**PRODUCT NOTICE**

## **ACS800 EconoPACK+ IGBT modules to TIM foil**

Picture 1. TIM foil on R8i heatsink

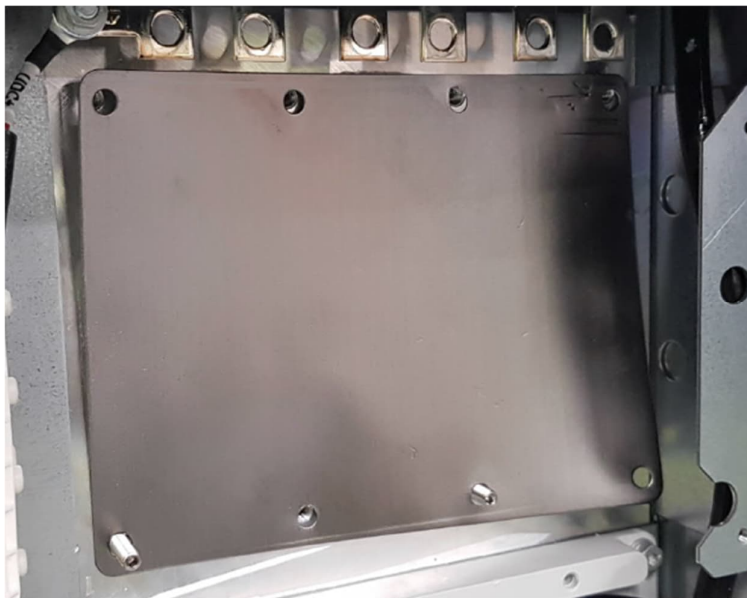
TIM foils or otherwise known as graphite sheet have been introduced in use in ACS800 modules using EconoPACK+ IGBT as part of normal continuous improvements in the ACS800 product family. Benefits of using TIM foils in comparison to thermal grease are easier installation and more durable heat transferring properties for longer periods of time. Durability particularly improved in a cyclic application.

TIM foils are used to transfer the heat generated in the IGBT's to the heatsink. Full instructions on how to install TIM foils is described in document delivered with TIM IGBT spare part kits. It's possible to use a mix of IGBT's with thermal grease and TIM foils. In parallel connected R8i modules it's also possible to use a mix of modules using TIM foils and thermal grease.
